SUITE 311
ORIGINAL LAYOUT
INVENTORY SUIT

*** SUITE 311 * (INVENTORY SUITE)**
NEW PLAN
-REMOVED DEN
-REVISED KITCHEN
*REVISED LAUNDRY DOOR SWING & ENSUITE WALL AS PER THIS BROCHURE

SUITES 311 - NOYAC BAY (Inventory suite)

ROOM: KITCHEN FLOOR PLAN

*** KITCHEN ***

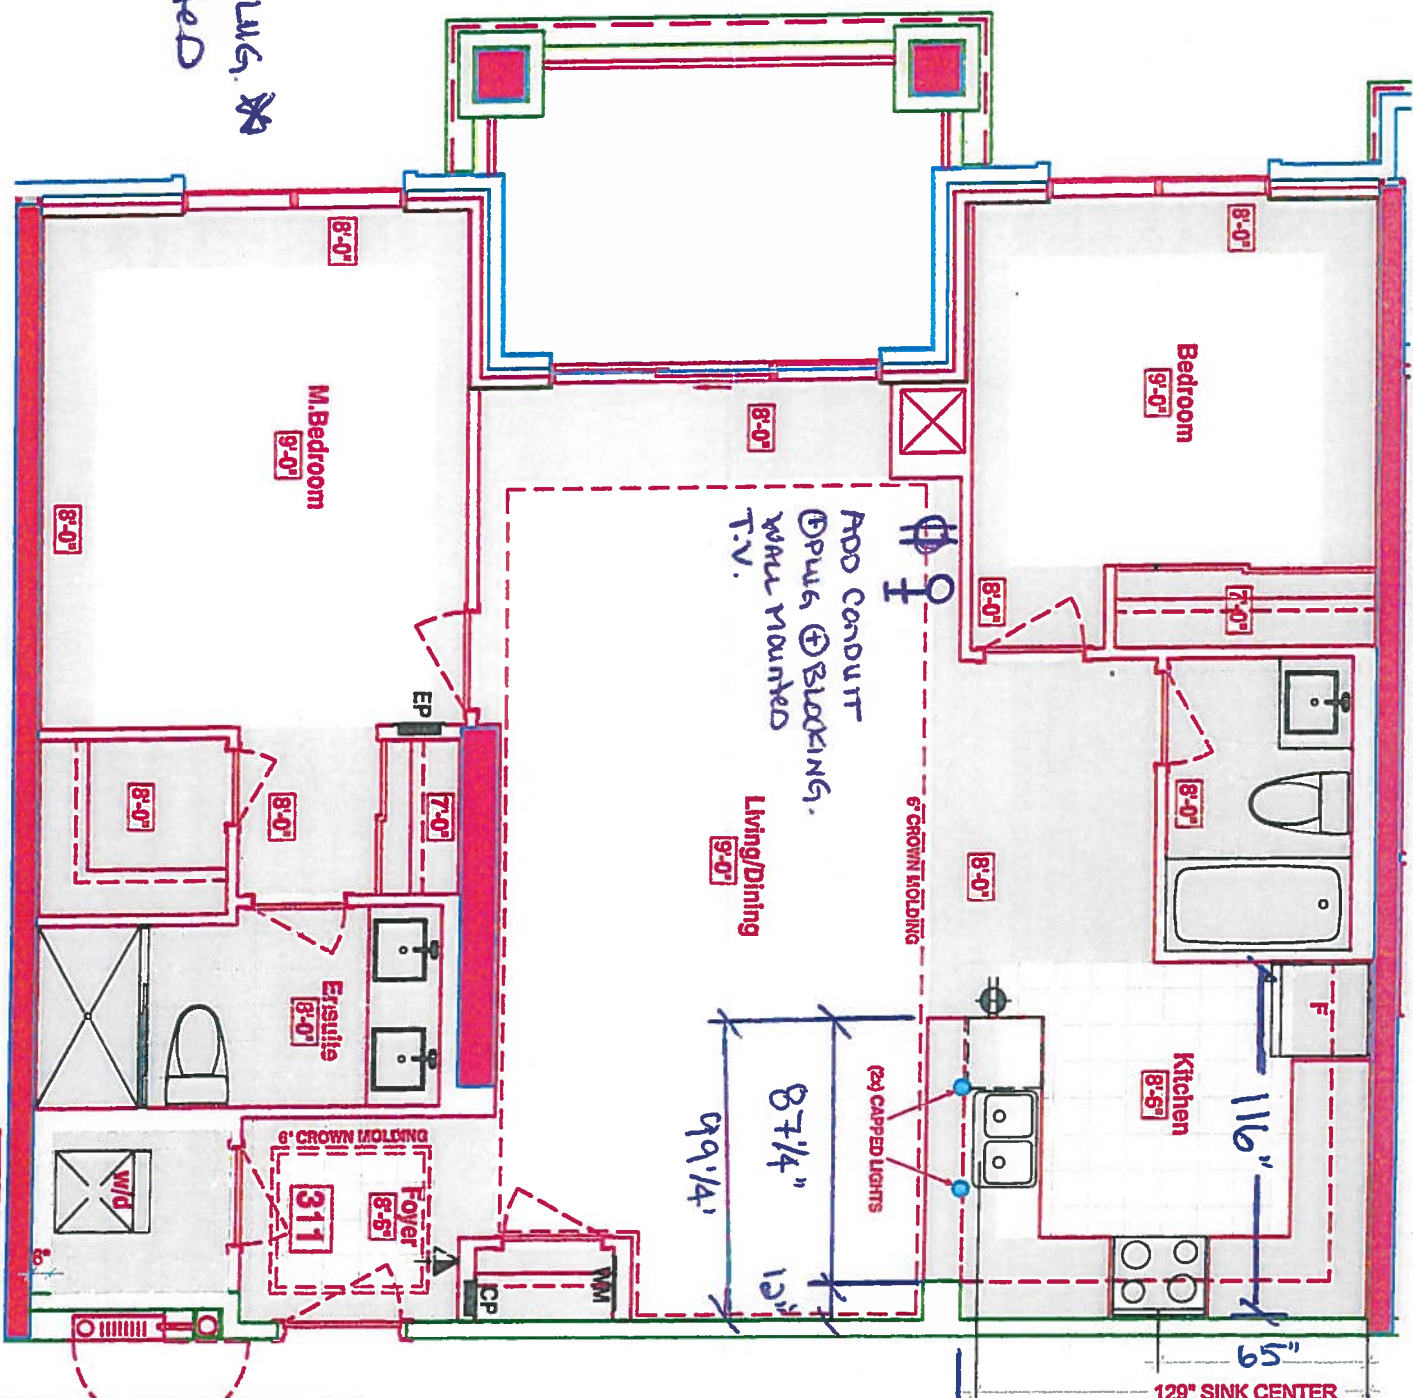
- STD Kitchen Layout
- 1st Upgrade Appliance Pkg w/ 36" Fridge @ Chimney Hood Fan @ Micro Drawer.
- (x2) = Pendant Lights
- (x5) = Puck Lights
- (x1) = Peninsula Plug
- 65" = stove Pipe Center
- 129" sink Pipe Center
- * Powder Room + Ensuite 36"14 Raised Vanities NO CHARGE @ 3" SPLASH

* Living Room Conduit/Plug. *
Blocking wall mounted T.V.

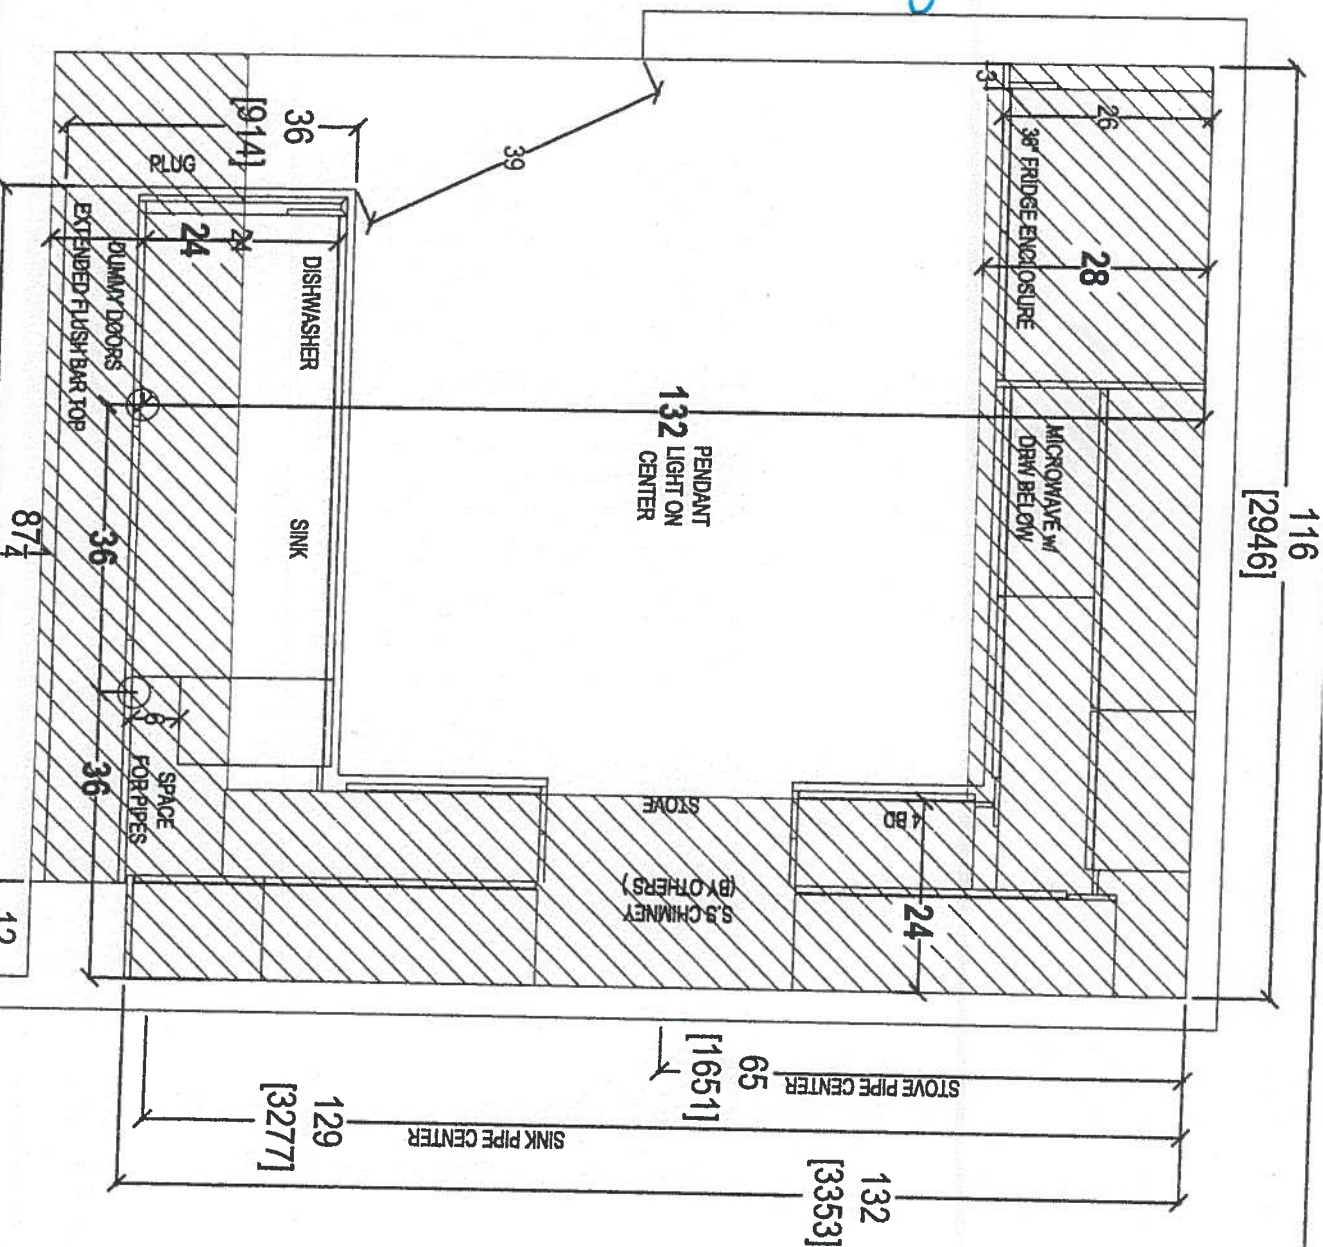
- STD Kitchen Layout
- URG#1- Appliance Pkg. w

36" REFRIG & CHIMNEY Hood

- NOTE: MICRO DRAWER (needs micro w spec)

- (x2) = PENDANT LIGHTS
- (x5) = PUCK LIGHTS
- (x1) = PENINSULA PUCK

* Powder Room + ENSUITE
RANSO YAMUNITES 36 1/4 (NO CHARGE)
⊕ 3" splash.

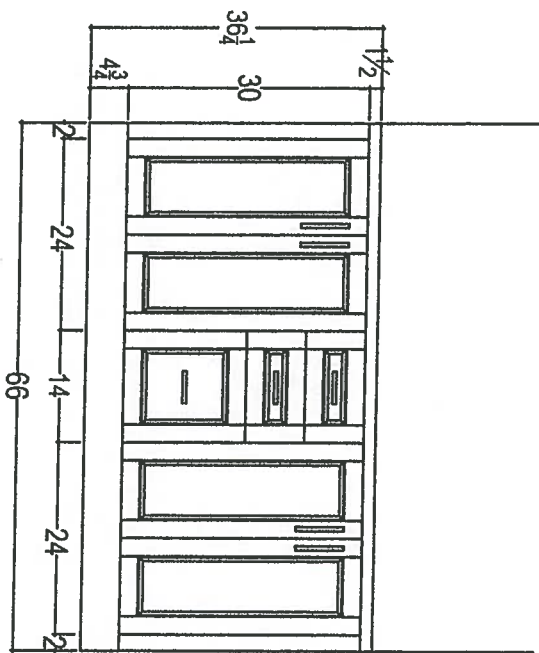
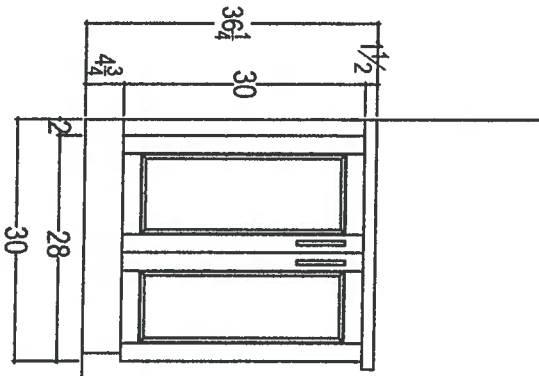
* RARE VANITIES
As per forge
No charge (+)
3" splash.
